# DRAINAGE INFORMATION SHEET

PROJECT TITLE: 7507 ZUNI S.E. ZONE ATLAS/DRNG. FILE #: K-19/D46A  
 LEGAL DESCRIPTION: Lot 7-2 SHAW ADDITION  
 CITY ADDRESS: 7517 ZUNI RD N.E.  
 ENGINEERING FIRM: C.A. Coonce & Assoc., Inc. CONTACT: C.A. Coonce  
 ADDRESS: 12324 Pineridge N.E. 87112 PHONE: 296-1089  
 OWNER: Joe Cruz CONTACT: \_\_\_\_\_  
 ADDRESS: 7505 ZUNI RD S.E. PHONE: 265-6906  
 ARCHITECT: None CONTACT: Joe Cruz  
 ADDRESS: \_\_\_\_\_ PHONE: \_\_\_\_\_  
 SURVEYOR: J.N.S. Systems CONTACT: Jerry Nickels  
 ADDRESS: 14320 Bauer N.E. PHONE: 292-3811  
 CONTRACTOR: Owner CONTACT: \_\_\_\_\_  
 ADDRESS: \_\_\_\_\_ PHONE: \_\_\_\_\_

RE: REVISED DRAINAGE PLAN FOR 7517 ZUNI ROAD, SE  
(K-19/D46A) ENGINEER'S REVISION DATED APRIL 16, 1987

TITLE **SITE-LANDSCAPE-DRAINAGE & GRADING PL.**

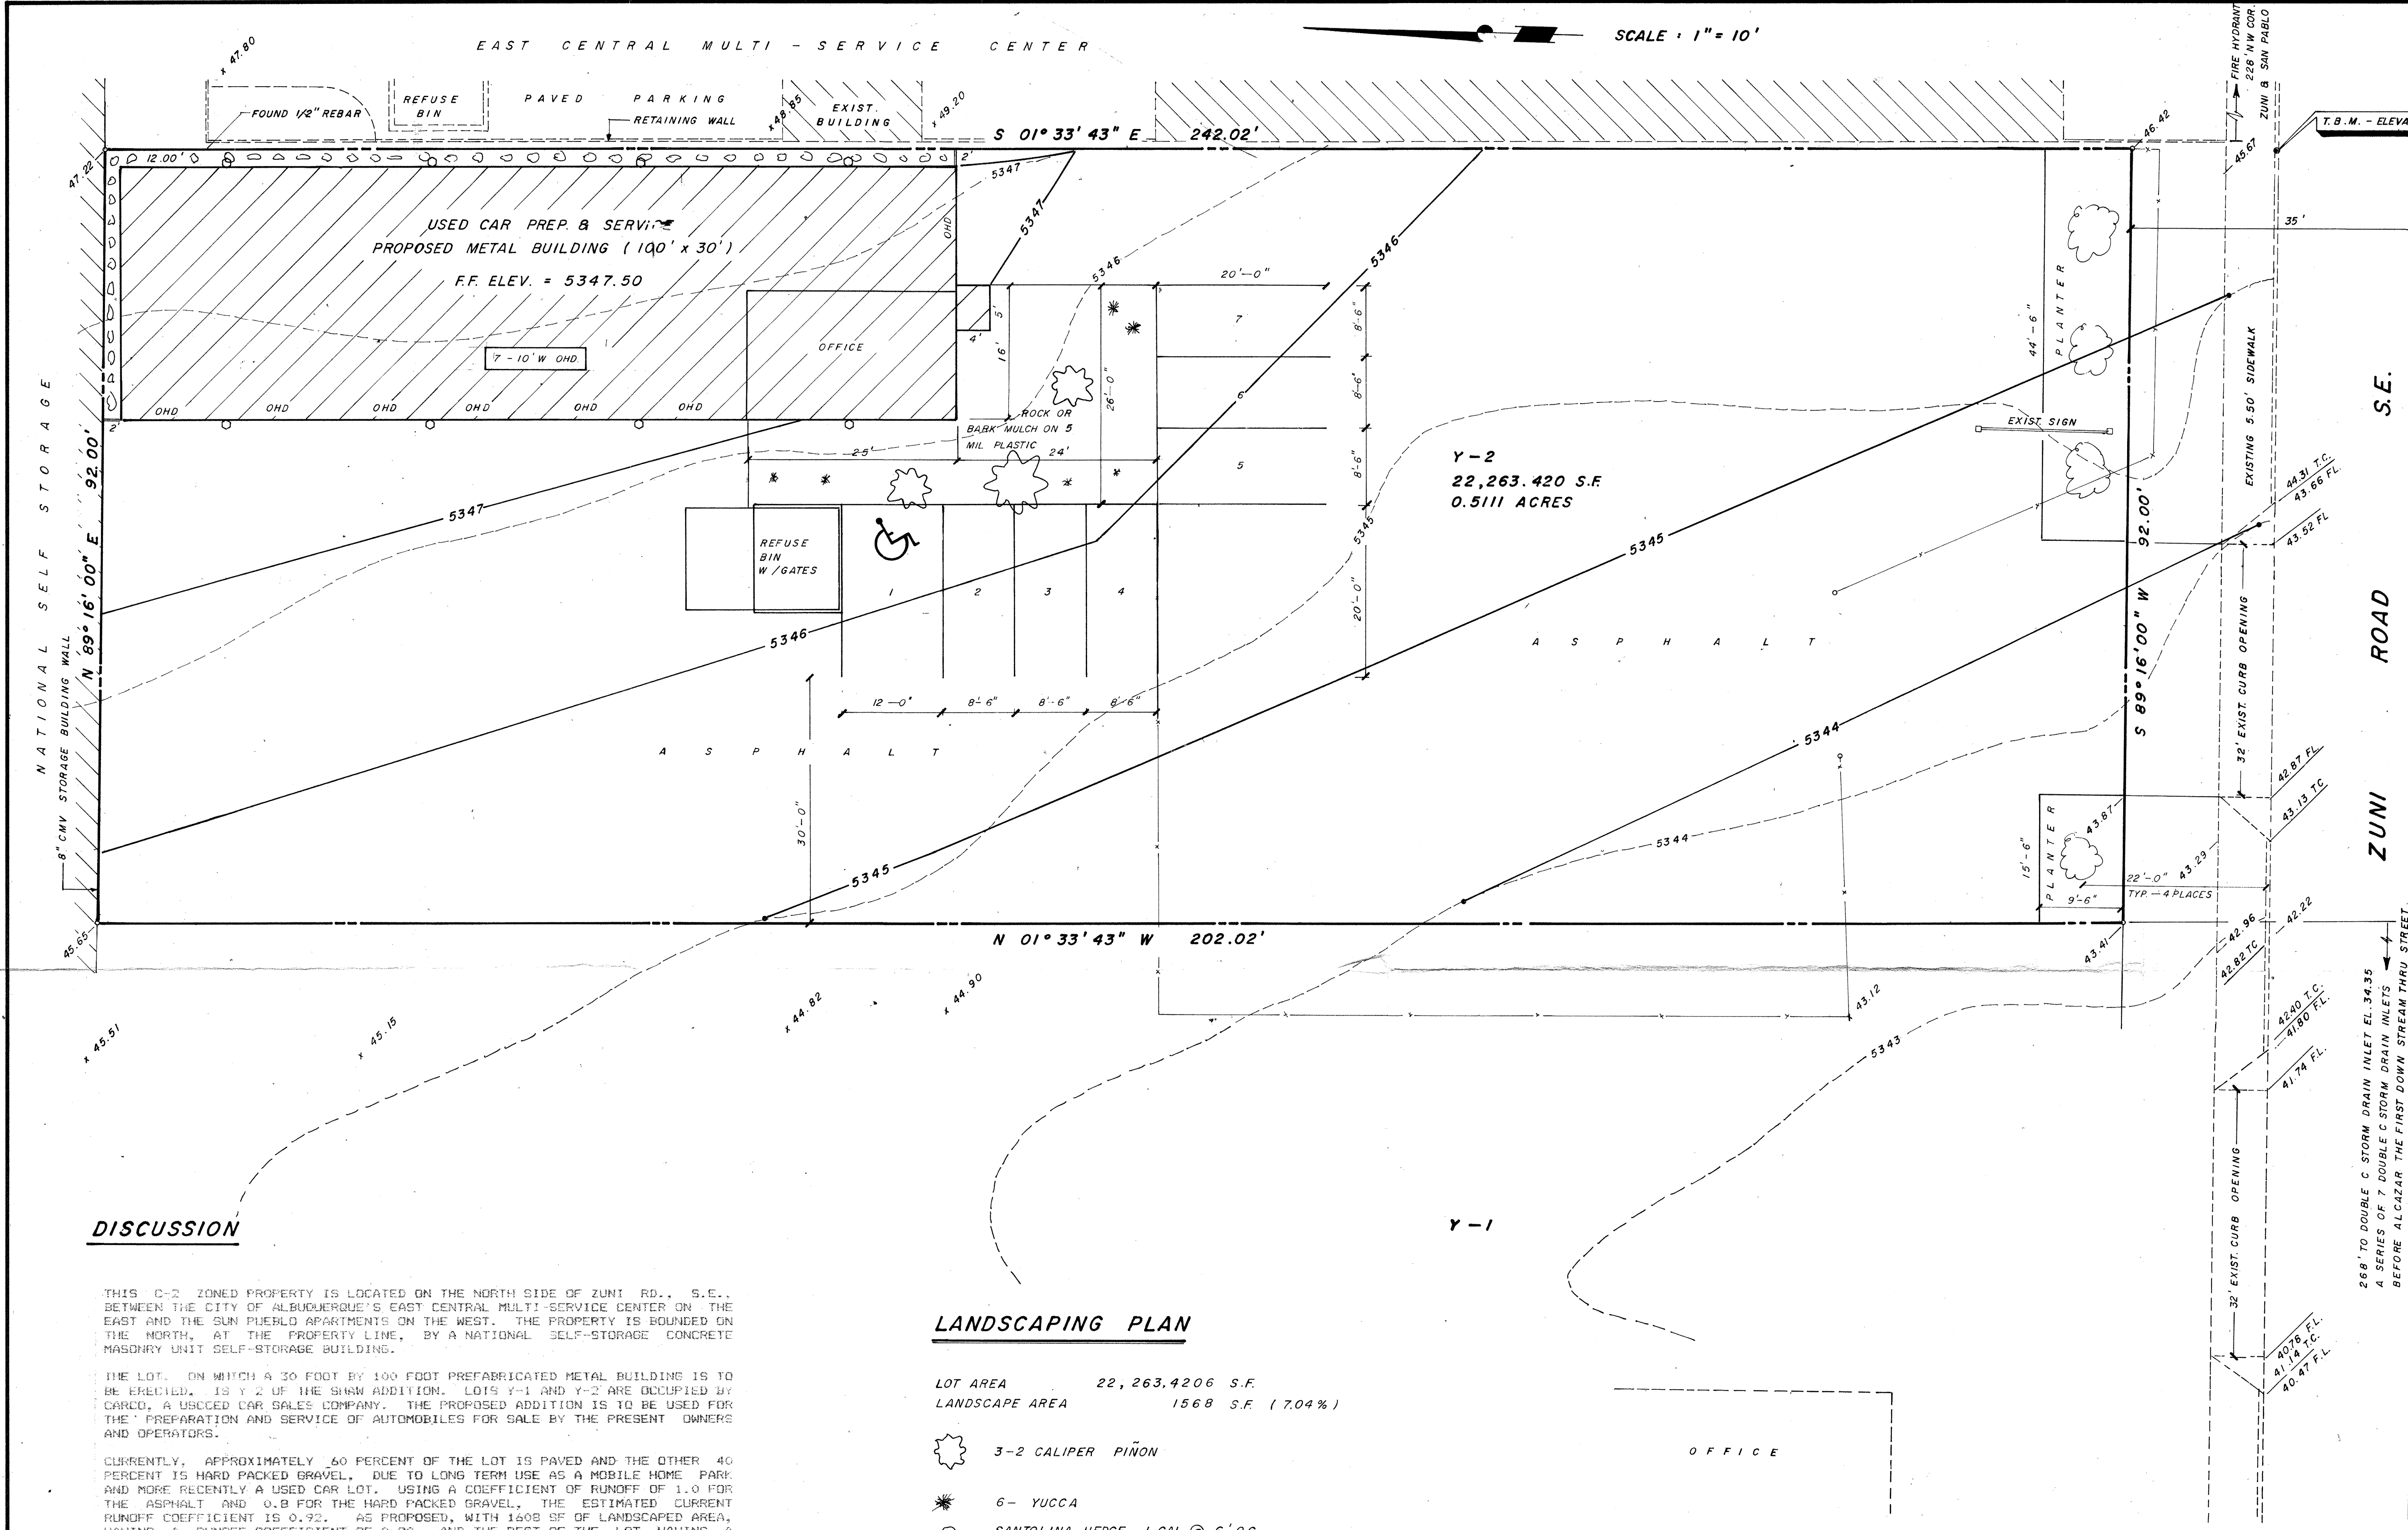
Based on the information provided on your resubmittal of April 16, 1987,  
the above referenced plan is approved for Building Permit.

Please attach a copy of this plan to the construction sets prior to  
sign-off by Hydrology.
